REMARKS

Title: CHILD SEAT WITH OBJECT HOLDER Inventors: Bruce WILLIAMS et al. Appl. No.: 10/691,618 ANNOTATED MARKED-UP DRAWING

FIG. 11

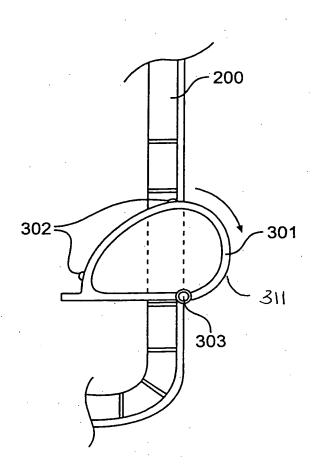
The Office Action objects to the drawings, stating that they must show the cavity and sidewall. Applicants have submitted proposed amendments to Figures 2 and 11 to overcome this objection.

The drawing sheets attached in connection with the above-identified application containing Figures 2 and 11 are being presented as new formal drawing sheets to be substituted for the corresponding previously submitted drawing sheets. Figures 2 and 11 have been amended. Appended to this amendment are annotated copies of the previous drawing sheets which have been marked to show changes presented in the replacement sheets of the drawings.
